**Re: Kimber Residence  
0 Pinecrest Parkway**

This letter is to request that the Steep Slopes and View Preservation Review be continued at the February 16, 2020 meeting of the Planning Board.

- A. An alternative design for the house consisting of three sheet of drawings prepared by Gotham Design & Community Development Ltd. under the review of Laura Wakefield, R.A., dated as submitted January 30, 2020, for the Planning Board.
- B. A Narrative documenting the fact that the subject property has steep slopes and making a request for a Special Hardship Exception from the Planning Board to permit the limits stipulated in the Code under Section 240-5.A. to be exceeded.

**BASEMENT FLOOR PLAN**  
SCALE : 1/8" = 1'-0"  
GRAPHIC SCALE IN FEET  
0 1 2 4 8 16

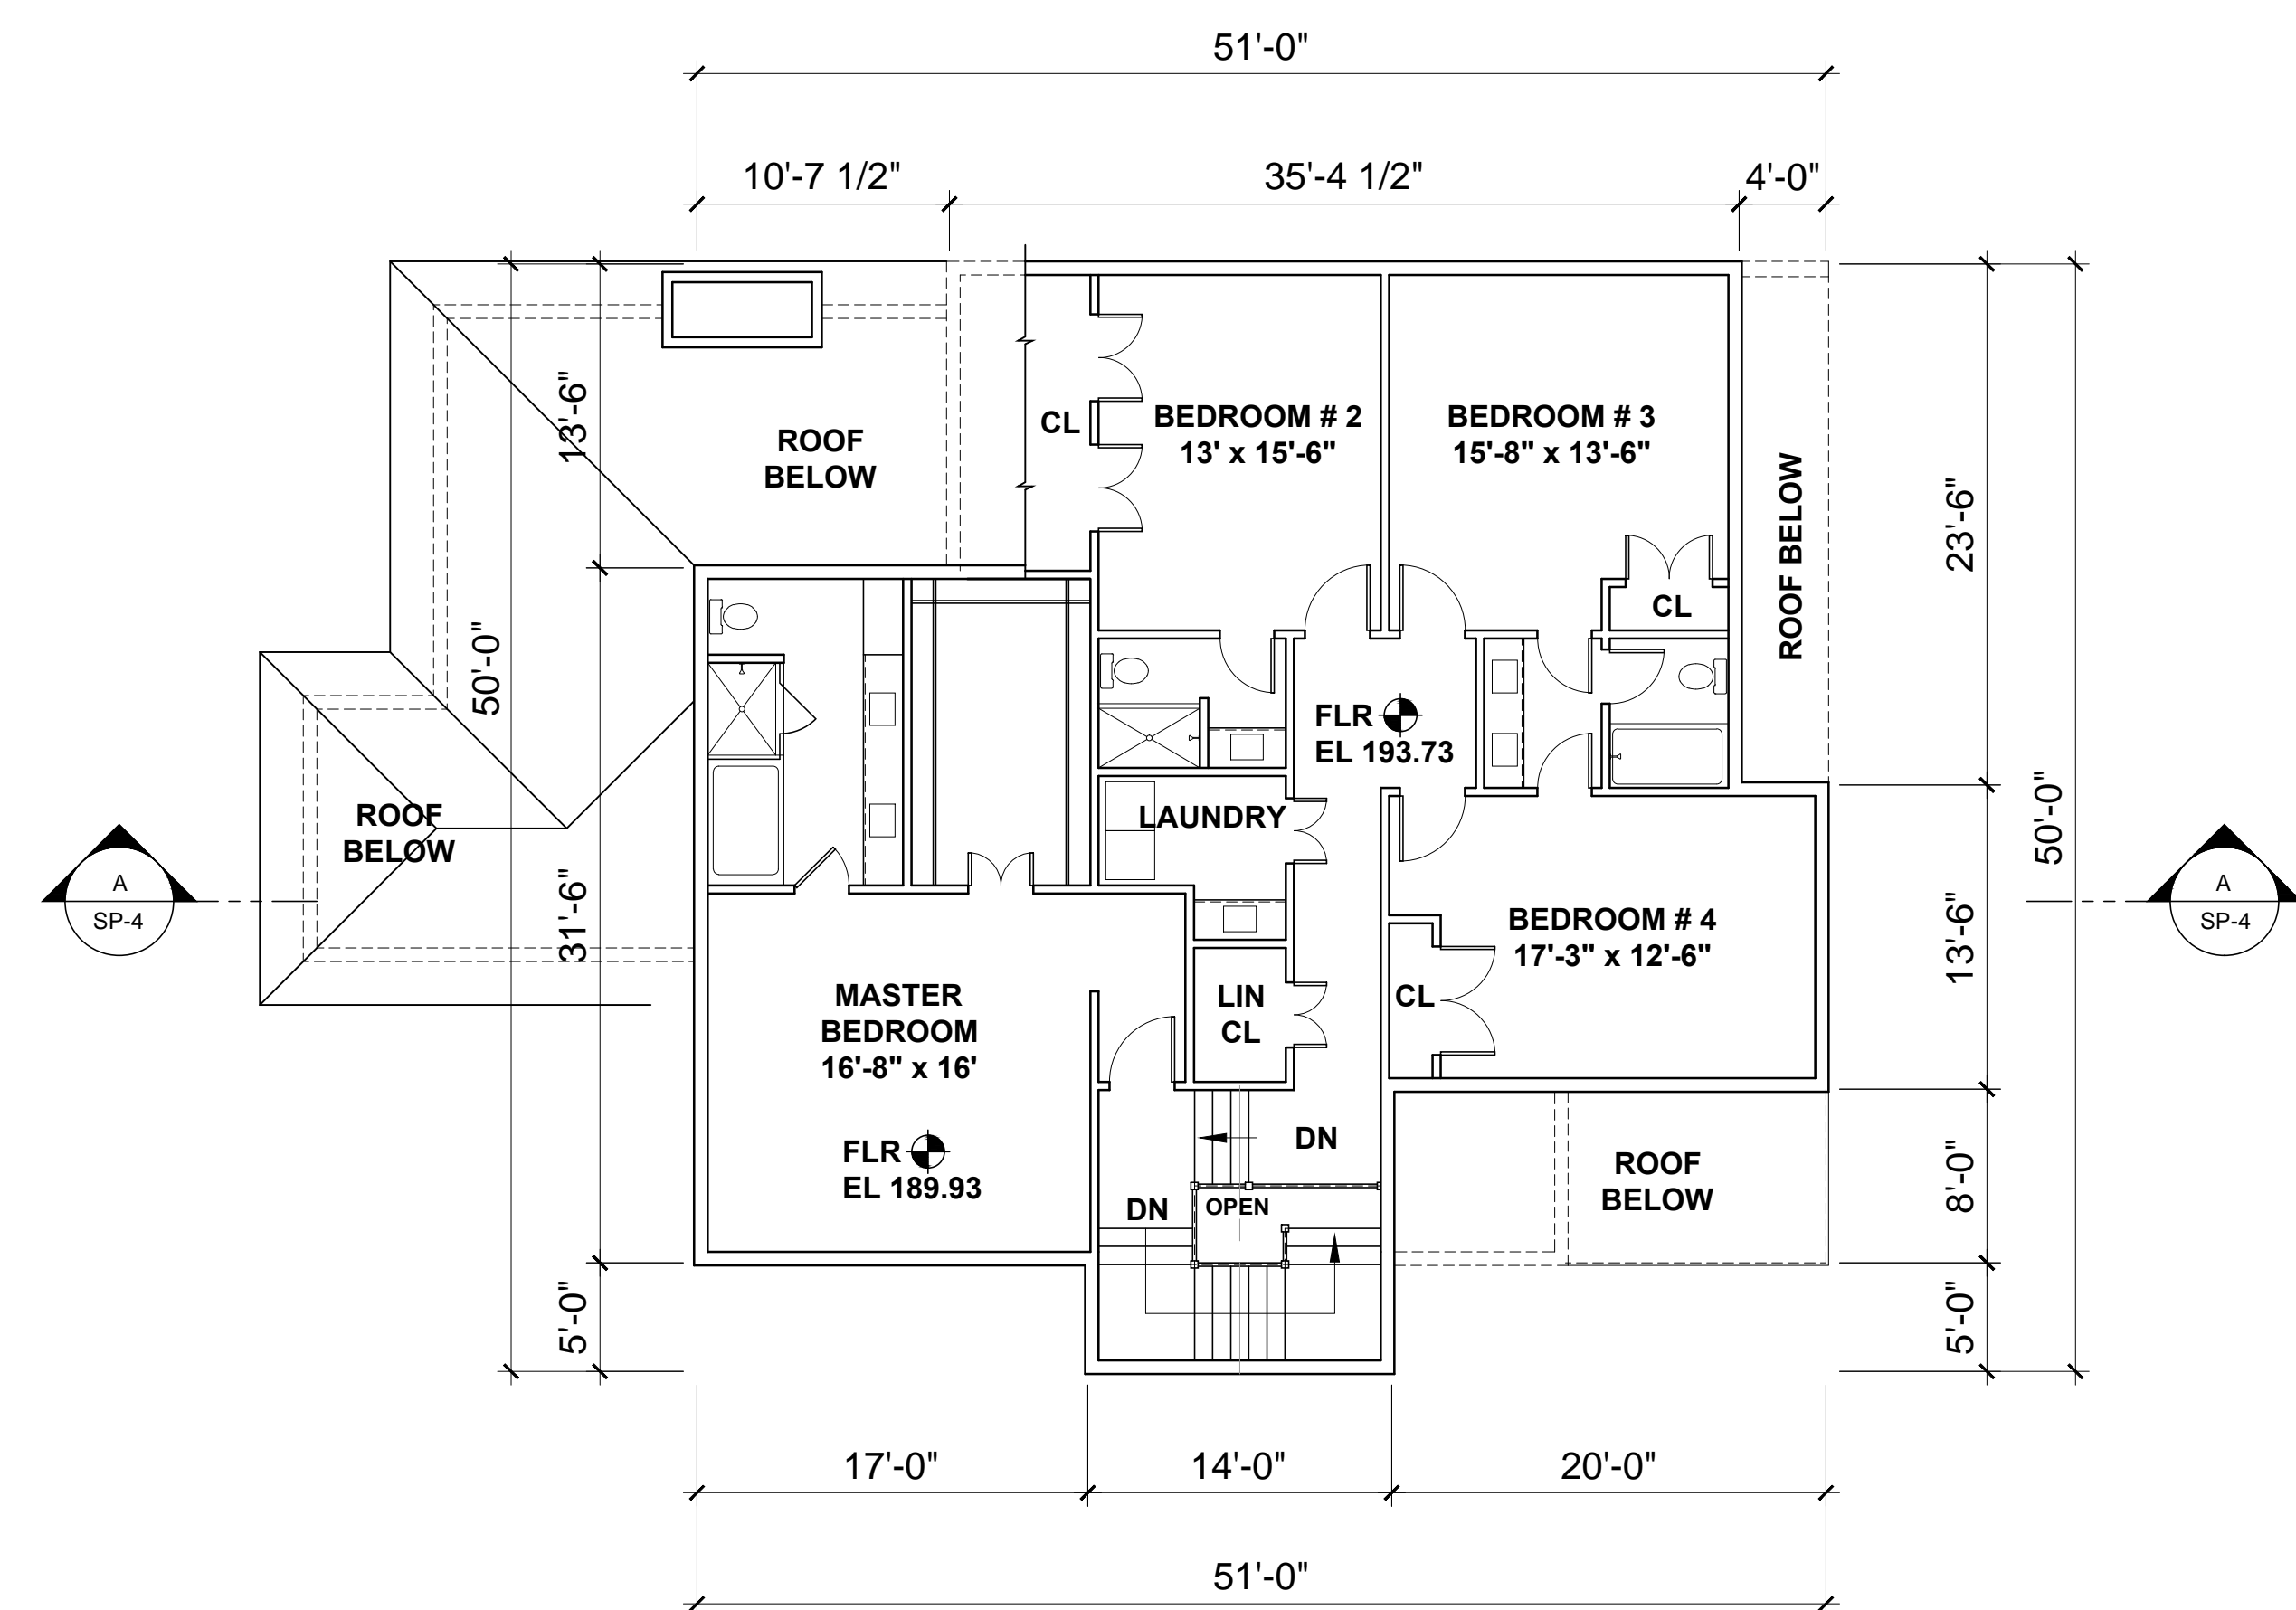
6. The alternative design has a split level such that the west half of the house has a first floor elevation of 178.6 and the east half of the house has a first floor height of 182.4. Similarly, the west half of the house has a second floor height of 189.93 and the east half of the house has a second floor height of 193.73.

7. Both the original design and the alternative design are configured such that the second floor ends significantly short of the extent of the first floor to the west. This is to reduce the mass of the house as perceived from the Aqueduct.
